## **ANZCDACC Product Defect Correction Notice 17<sup>th</sup> Jan 2019**

**Device:** Programmer Software Update supporting the Micra Transcatheter Pacing System (TPS)

Medtronic 2090 Carelink Programmer, 29901 Encore Programmer, Carelink Network Application software 2491

Image 1

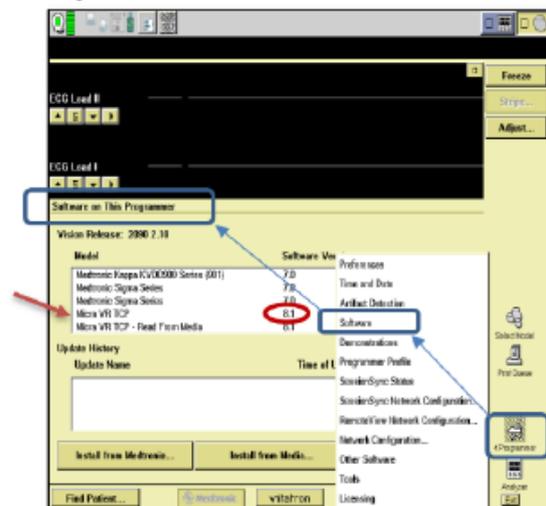
- Select Software (see image 1)
- Scroll through the list of available Software Models in the top selection box until you locate the Micra selection
- Verify the Software Micra VR TCP Version is 8.1

Correct software: Micra VR TCP version 8.1 (or higher)
